**CRITICAL AREAS RECHARGE REPORT
PROPOSED TOWNHOUSES
8502 - 166TH AVE NE & 16640 NE 85TH ST
REDMOND, WASHINGTON**

**Subject: RESPONSE TO CITY OF REDMOND COMMENTS - 3/23/15
 PROPOSED TOWNHOUSES
 8502 - 166TH AVE NE & 16640 NE 85TH ST
 REDMOND, WASHINGTON**

**Subject: RESPONSE TO CITY OF REDMOND COMMENTS - ADDENDUM
 PROPOSED TOWNHOUSES
 8502 - 166TH AVE NE & 16640 NE 85TH ST
 REDMOND, WASHINGTON**

V-7

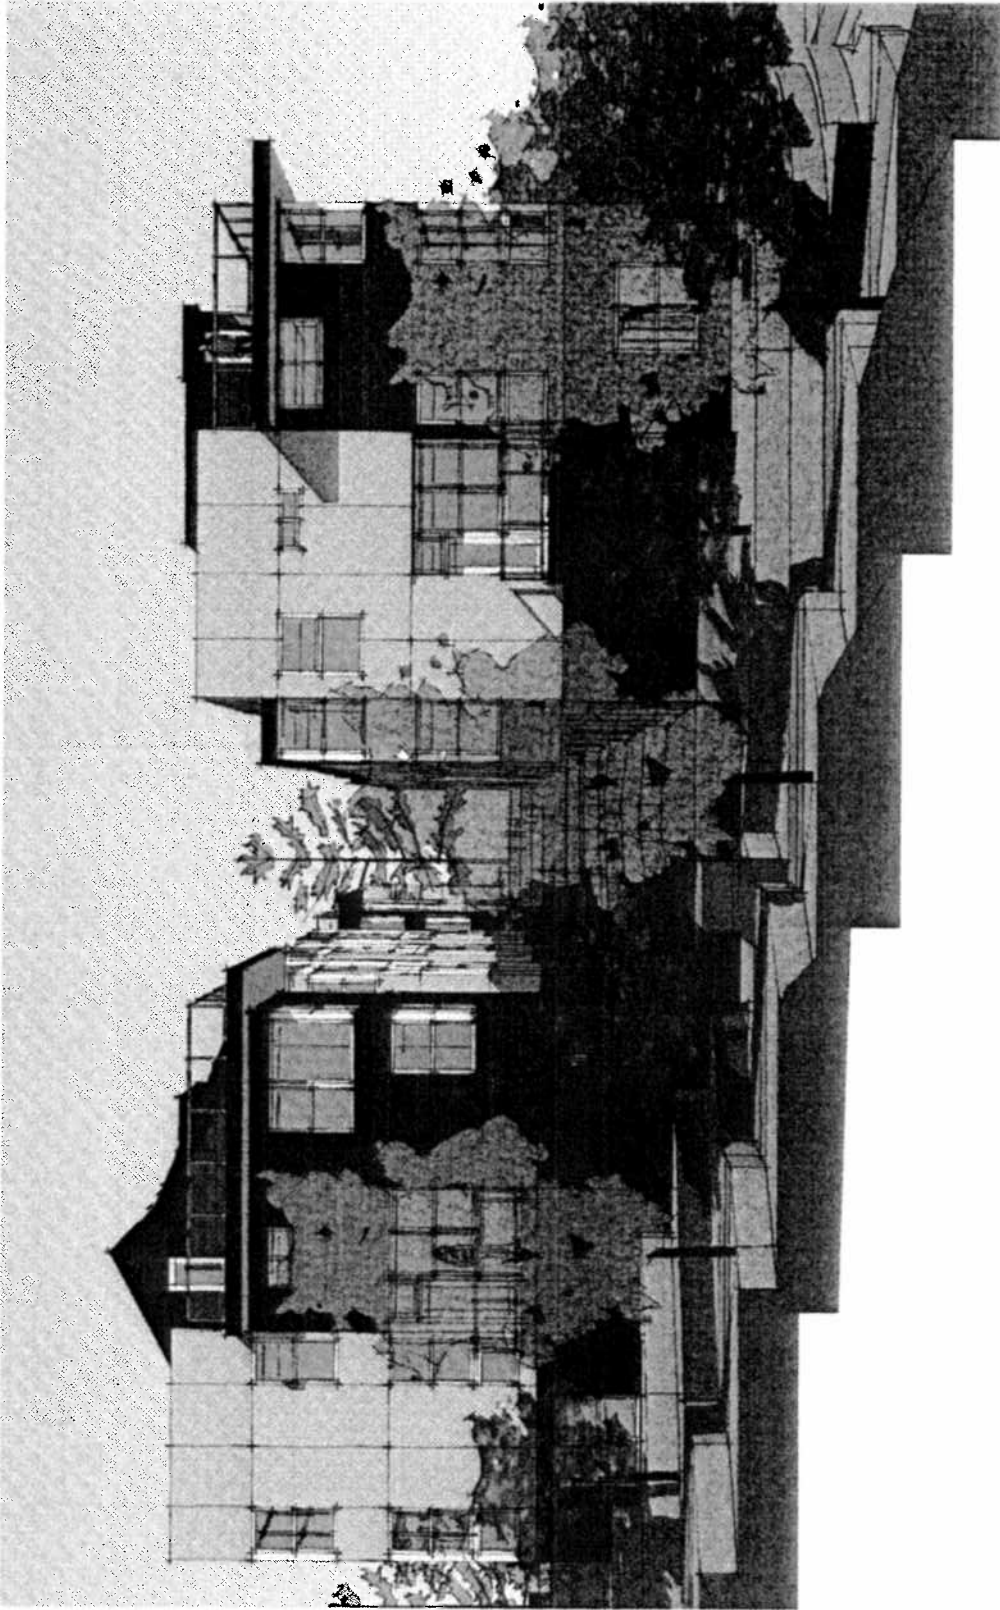
Comment #5:

Add a discussion about how groundwater should be managed on-site for this project, both during construction and long term. Show a cross-section of project with subsurface structures and seasonal high groundwater elevation.

Response #5:

Currently, the project plans have not been developed with floor elevations. So it is not possible to provide an accurate cross-section of the development. However, we have attached Elevation Model Views V-7 and V-10 by Daniel Umbach which show how the project has been designed to step down the hillside thereby minimizing the amount of excavation which will occur. Based upon discussions with Mr. Umbach we understand that the deepest excavation below existing grade may have a depth of around 8-feet near the northeastern corner of the property.

GRADING PLAN
 PROPOSED TOWNHOMES
 8502 - 166TH AVE NE & 16640 NE 85TH ST
 REDMOND, WASHINGTON

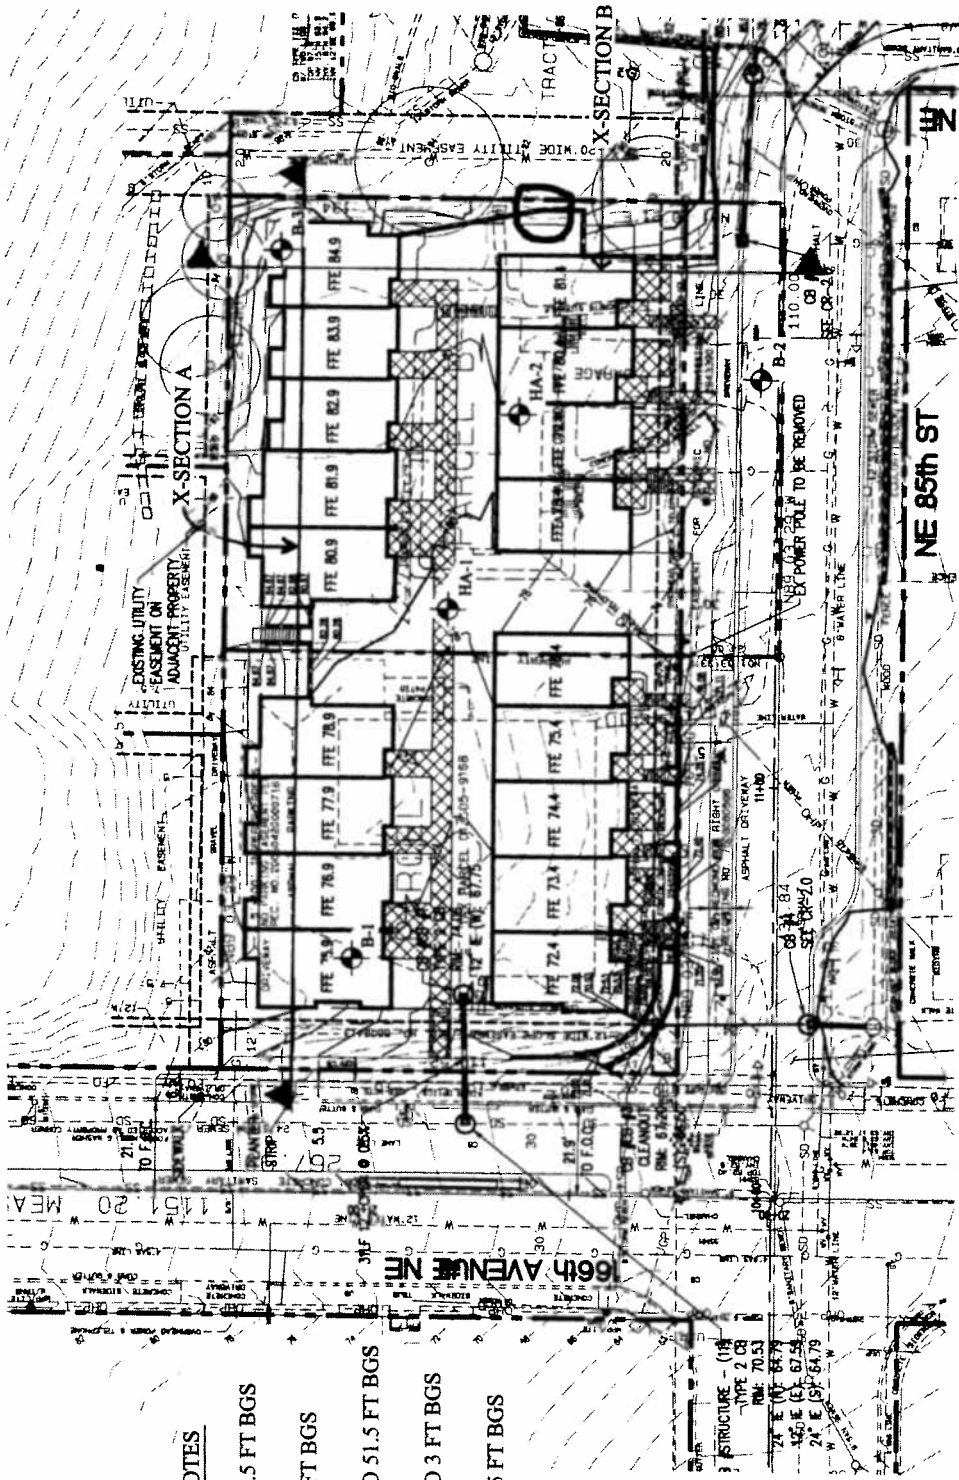
Comment #5:

Add a discussion about how groundwater should be managed on-site for this project, both during construction and long term. Show a cross-section of project with subsurface structures and seasonal high groundwater elevation. Further characterization of soils and groundwater is

A feasibility study may be required for temporary construction dewatering. See Draft Interim Construction Dewatering Policy and provide either a feasibility study or justification for not needing a study (5/21/15).

Response #5:

We have prepared the attached **Plate 1 - Grading Plan, Plate 2 - X-Section A - West/East and Plate 3 - X-Section B - North/South** to address the reviewer's comment. As shown the amount of excavation for the proposed development will not encounter the underlying aquifer and there is the possibility that excavations for the building pads will not encounter perched groundwater seepage either, as these sand lenses within the glacial till may not be connected. Based upon the cross-sections the maximum depth below existing surface for the proposed building pads is around 8-feet. We estimate that the average depth for building pad preparation is more like around 4-feet. Please note that the water seepage levels noted on the cross-sections are depths where perched water seepage was observed at the time of the borings. This water seepage is not indicative of a "water table" or the level of the underlying aquifer. In fact, it is important to note that the boring B-3 located at the high point at the site did not encounter any water seepage down to a depth of 51.5-feet below ground surface. The observed seepage zones signify that for a limited extent and depth and also for a likely limited time period a likely relatively small amount of water has collected within a sandier layer within the glacial till soils or at the interface between the medium dense and very dense glacial till soils. As previously noted in our referenced report and as also noted in the hydrogeologic report by ZZA / Terracon there is no known quantifiable connection between the perched seepage zones and the underlying water-bearing aquifers. These perched seepage zones may fill during the wetter periods of the year and

X-SECTION A - WEST/EAST

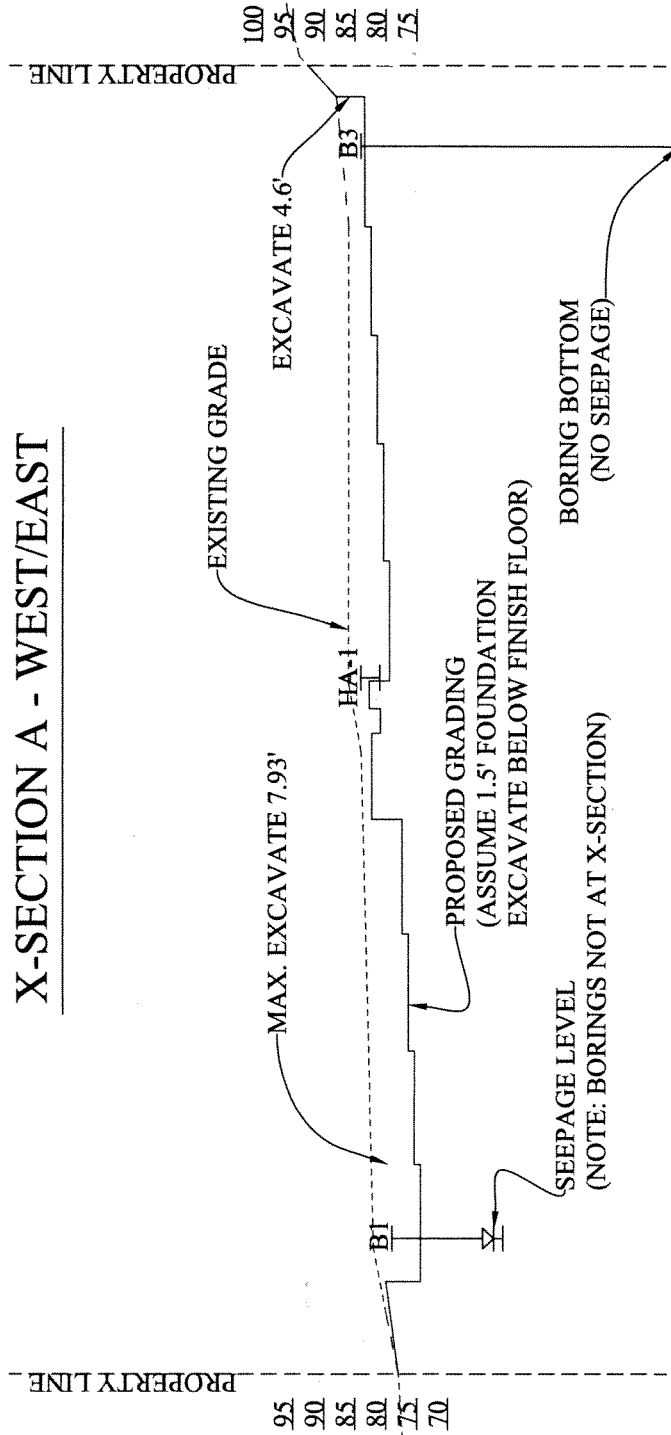
Comment #8:

Include a cross-section of subsurface structures and seasonal high groundwater elevation in plans.

Response #8:

We have prepared the attached cross-sections as previously noted in our Response #5. At the time of our previous response to the reviewer's comments (letter, 5/5/15) finish floor elevations were not available. Additionally, if the cross-sections are required on the plans, than the designer or civil engineer will need to add them to the plan documents.
